**REVISED TECHNICAL SPECIFICATIONS
AND TECHNICAL SPECIFICATION BASES PAGES**

REVISED UFSAR

UFSAR CHANGE DFL 97011
SHORT-TERM/LONG-TERM CONTAINMENT PRESSURE AND TEMP

FIGURE 6.3-83

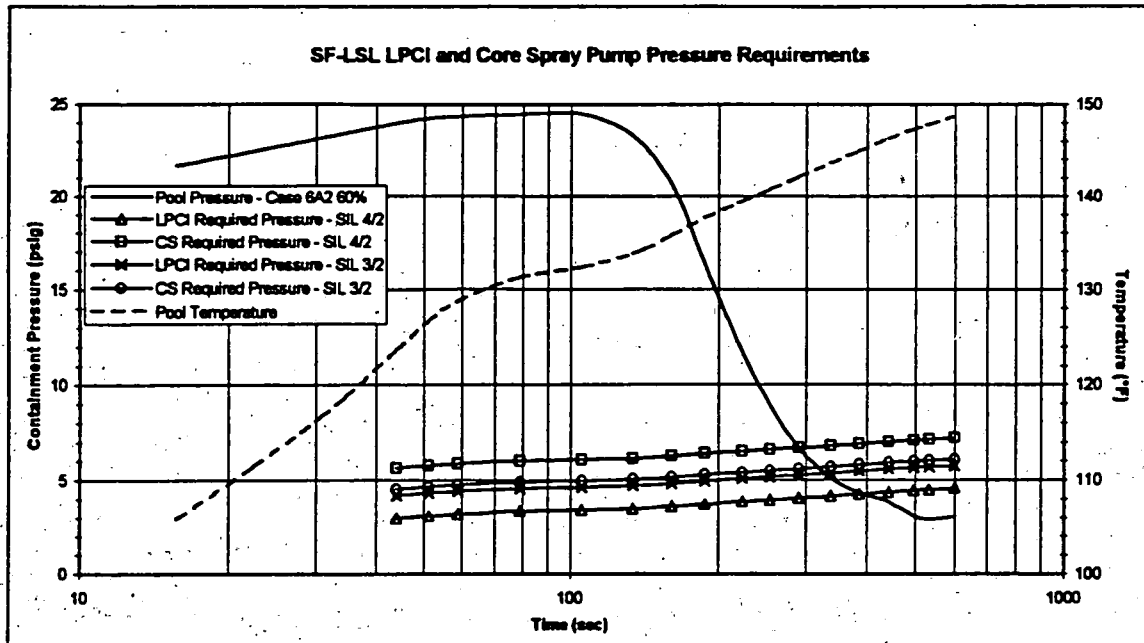
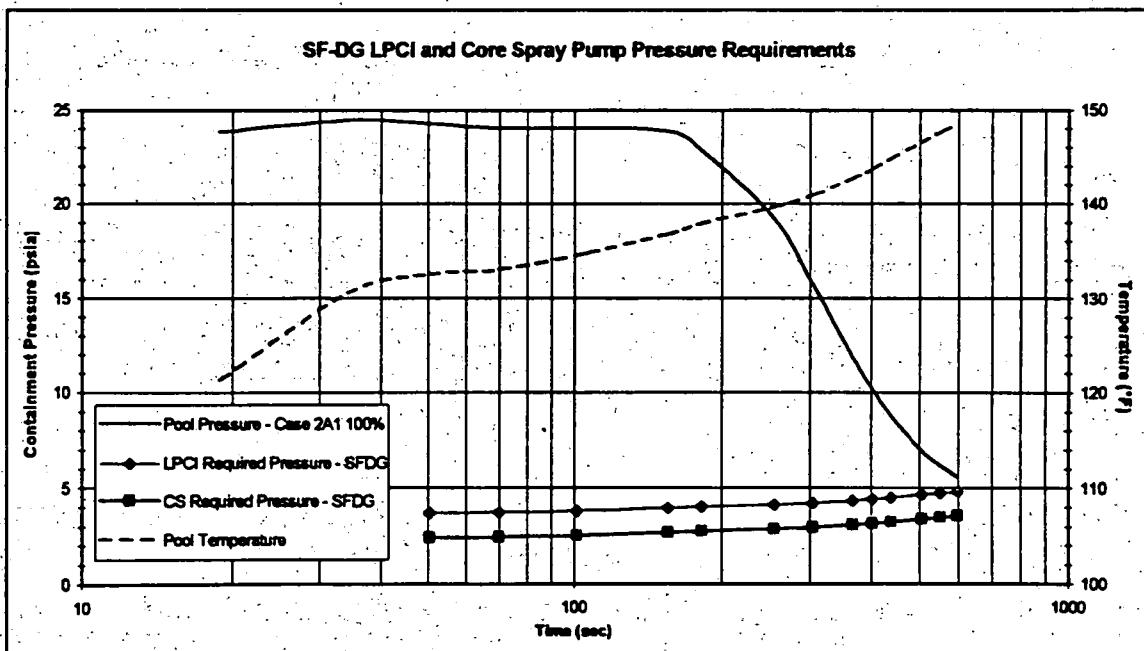
4	Figure 6.3-83	N/A	N/A	Initiated a new figure reflecting the current design information.
4	Figure 6.3-89	N/A	N/A	Initiated a new figure reflecting the current design information.
5	9.2.1.3	4	9.2.2	Added design information that identifies the operation and location of the differential pressure control valve for the LPCI heat exchanger and the minimum CCSW flow of 5000 gpm for containment cooling. A change issued under DFL96140 identifying a different flow rate is being deleted by this change. This change is a result of the Licensing Amendment to reevaluate LPCI and Core Spray pump requirements.
5	Table 9.2-1	N/A	N/A	A change to the table initiated under DFL 96140 identifying a flow rate of 5600 gpm is being deleted. The table should only reflect containment cooling service water equipment specifications. This change is a result of the Licensing Amendment to reevaluate LPCI and Core Spray pump requirements.
